8. Well Name and No.
LAGUNA 23 FEDERAL COM 2H9. API Well No.
30-025-4069710. Field and Pool, or Exploratory
LEA11. County or Parish, and State
LEA COUNTY, NM

Nearburg Producing Company respectfully requests approval to change the directional plan and casing for the above referenced well:

Cimarex Laguna 23 Federal Com #2H Rev0 TP 12-Dec-13 Proposal Report

CONDITIONS OF APPROVAL

Job Recommendation Surface Casing

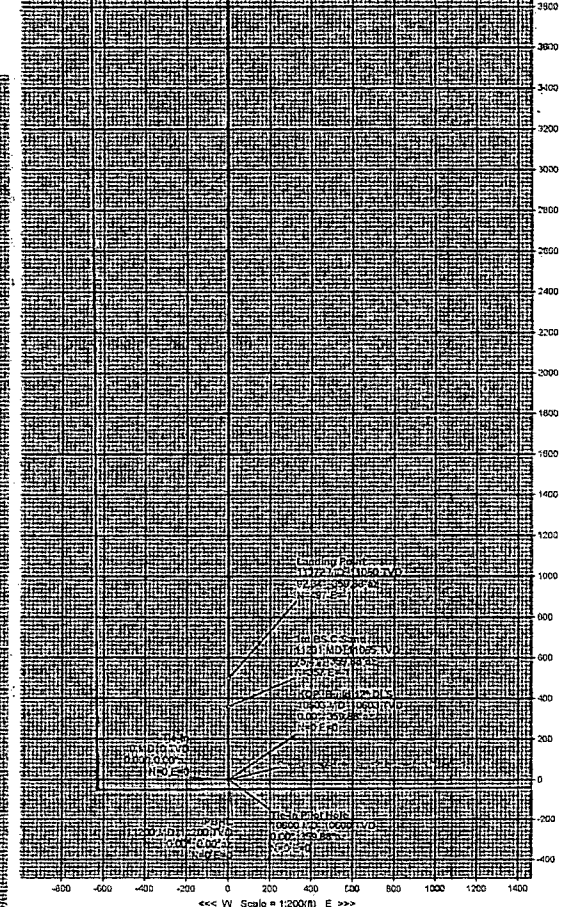
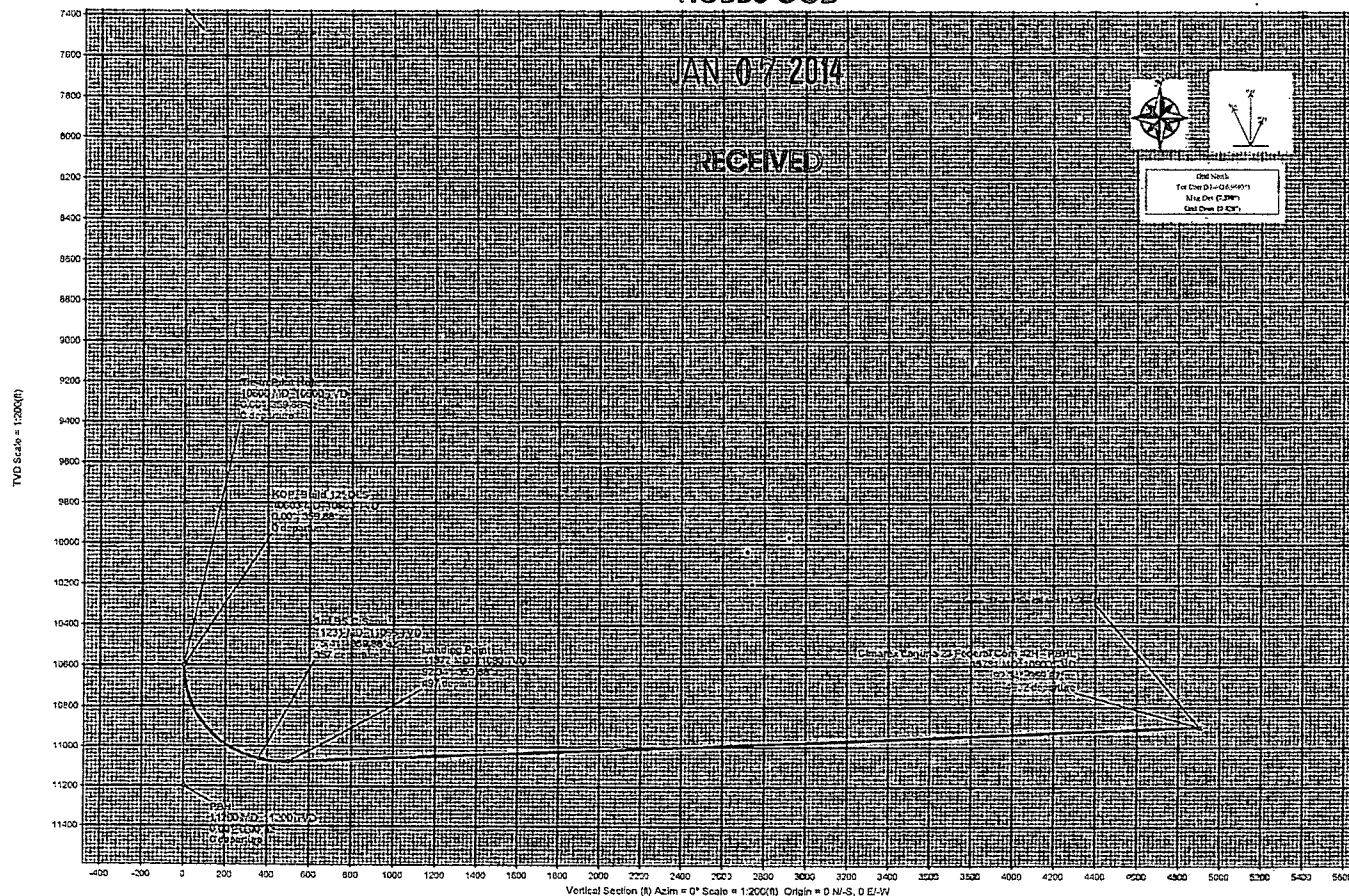
Yields? assumed
same as before
See e-mail
on next page

Fluid 1: Lead
ExtendaCem – CZ

Fluid Weight	13.50 lbm/gal
Slurry Yield:	1.75 ft ³ /sk
Total Mixing Fluid:	9.20 Gal/sk

Fluid 2: Tail-in
HalCem – C
1 % Calcium Chloride - Flake (Accelerator)

Fluid Weight	14.80 lbm/gal
Slurry Yield:	1.34 ft ³ /sk
Total Mixing Fluid:	6.36 Gal/sk
